SUNDRY NOTICES AND REPORTS ON WELLS
Do not use this form for proposals to drill or to re-enter an abandoned well. Use form 3160-3 (APD) for such proposals.

3. Well Name and No.
GALLEGOS CANYON 160

The subject well was approved on 10/15/2001 for recompletion into the Otero Chacra. Please note the change in procedure from recompletion to plug and abandonment as per the attached procedure.

GCU Com D 160 - Proposed P&A Configuration
 San Juan County, NM
 Unit I Section 27 T29N - R12W
 Run 23

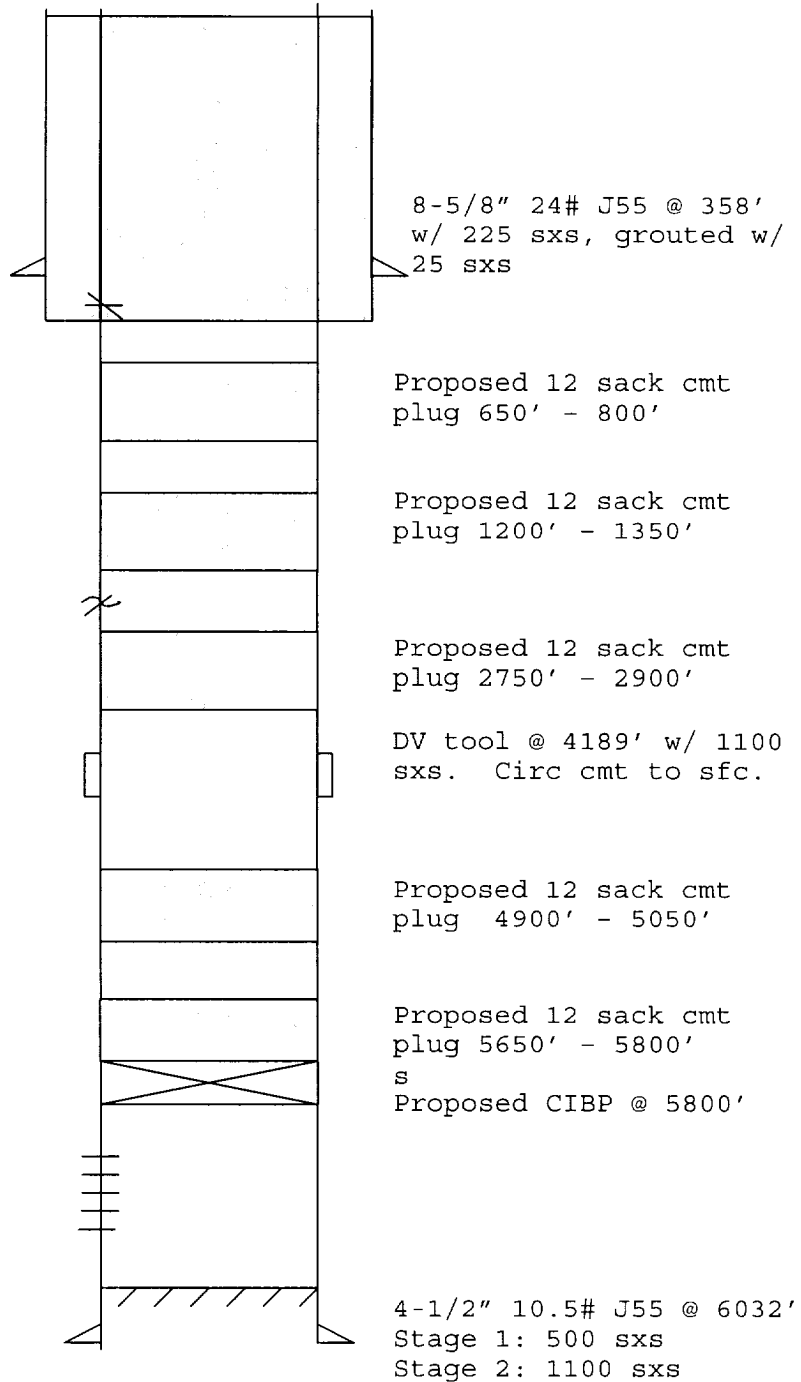
Proposed sqz perfs @
 375' w/ 100 sxs,
 leaving 28 sxs
 inside csg

6. POOH with 2-3/8" tbg, visually inspecting.
7. TIH with CIBP on tbg. Set CIBP at 5800' to abandon the DK perms.
8. Spot 12 sack cmt plug 5650' – 5800' to isolate the DK.

9. Spot 12 sack cmt plug 4900' – 5050' to isolate the GP.
10. Spot 12 sack cmt plug 2750' – 2900' to isolate the MV.
11. Spot 12 sack cmt plug 1200' – 1350' to isolate the PC.

12. Spot 12 sack cmt plug 650' – 800' to isolate the FT.
13. Perf 4-1/2" csg @ 375' w/ 4 SPF. Attempt to circulate to surface. Sqz with 100 sxs, leaving 28 sacks inside csg.
